UTILITIES COMMISSION
City of New Smyrna Beach, Florida
200 Canal Street
P.O. Box 100
New Smyrna Beach, Fl. 32170-010

RE: ITB 28-20 Annual Contract Pole Inspection Program
ADDENDUM No. 1

Typical Birthmark

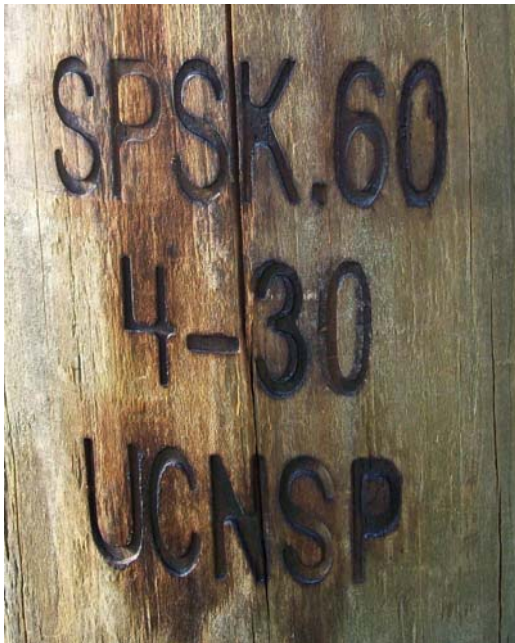
10) What type of stencil is being applied?

- See attached Pole numbering and Birth mark standards.
- See answers to Item 2

Please include birthmark information from bottom two lines (left image) for any new power pole installation (or replacement) with returned work order paperwork after job completion so that maps & database can be updated.
